REMARKS

This application has been reviewed in light of the Office Action dated August 13, 2003. Claims 1-14 are pending in the application. By the present amendment, the specification has been amended to correct a typo. No new matter has been added. The Examiner's reconsideration of the rejection in view of the amendment and the following remarks is respectfully requested.

FIG. 1

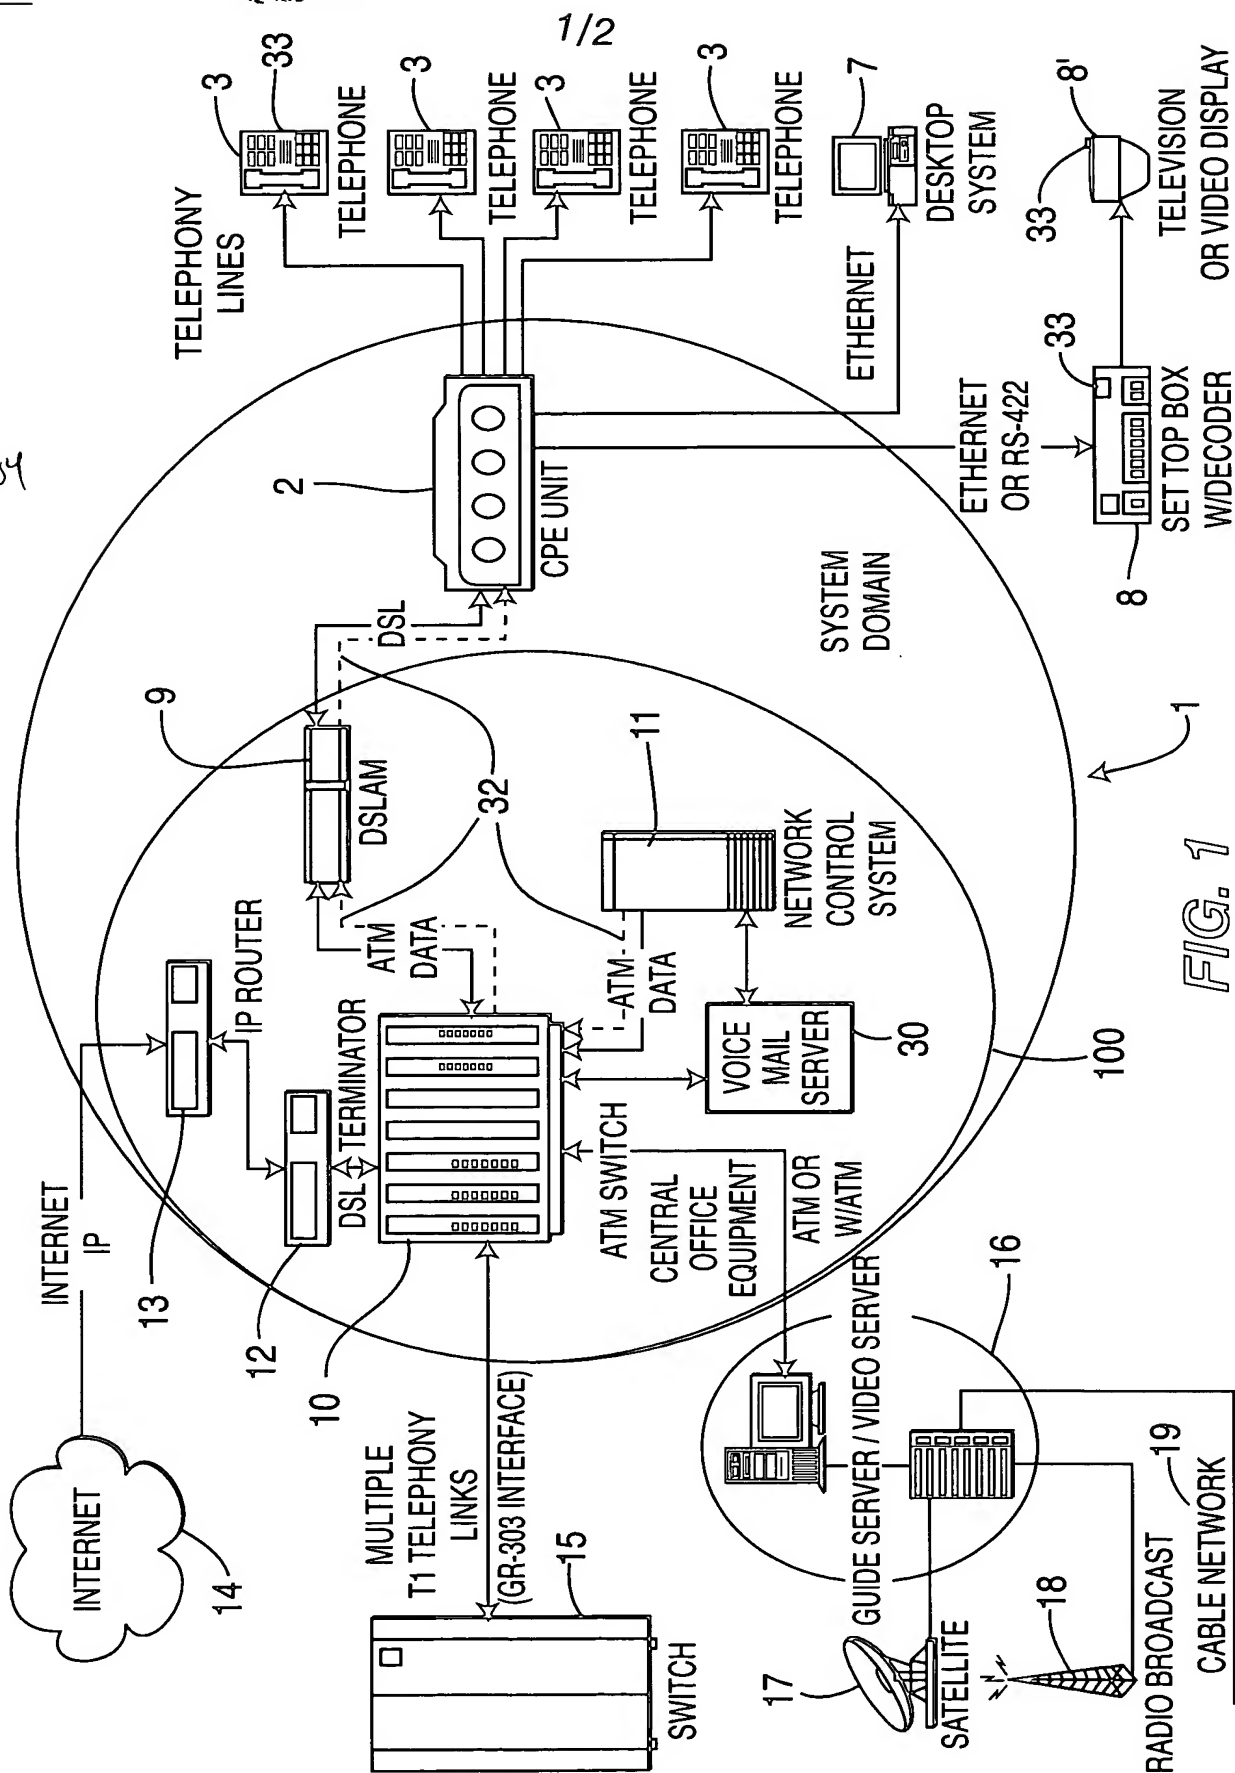
By the Office Action, the Examiner objected to the drawings because they did not include reference signs for PC 6 and line 32. The specification has been amended to correct the reference sign to PC 7, which is shown in FIG. 1. Please approve the changes to FIG. 1, enclosed herewith, which now shows the reference number 32 for line 32 as set forth throughout the specification. Line 32 is indicated as the dotted line in FIG. 1. Reconsideration of the objection is respectfully requested.

Approved
mup 4/20/04
